United States Patent and Trademark Office

APPLICATION NO.	F	ILING DATE	FIRST NAMED INVENTOR	ATTORNEY DOCKET NO.	CONFIRMATION NO.	
10/634,276		08/05/2003	Andreas Fath	071308.0463	7127	
31625	7590	05/25/2005		EXAMINER		
BAKER BO	OTTS L.I	L.P.		KIM, CHRIS	STOPHER S	
PATENT DI		ENT LVD., SUITE 1500		ART UNIT PAPER NUMBER		
AUSTIN, T				3752	752	
					_

DETAILED ACTION

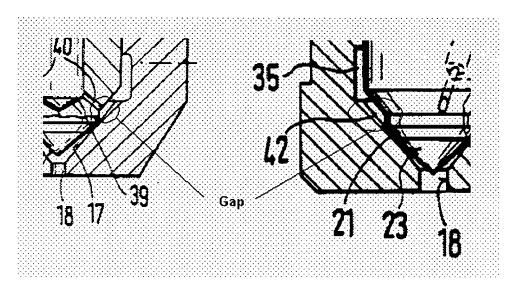
Applicant argues that Hoffman, Ushimura and Holzgrefe do not disclose "an outer surface of the nozzle needle running essentially parallel to an inner surface of the nozzle body in the region of the gap.

Ushimura discloses such a gap:
